Intersection ID: 14668	Main Street: BARRINGER_DR	Cross Street: MANCHESTER_DR	Location:	NW
ADA ID: 8A7445322D55	Ramp Type: ParaDiag	Initial Pass/Fail: Fail	Overall Compliance: No	Severity Score: 13.75

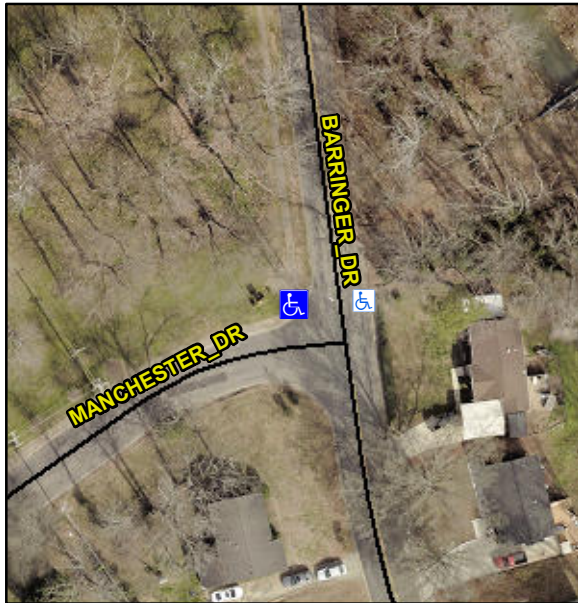
## NO RT RAMP

**R304.3.2, R304.5.3**

**Remove & Replace Curb Ramp With Two New Directional Ramps or Equivalent.**
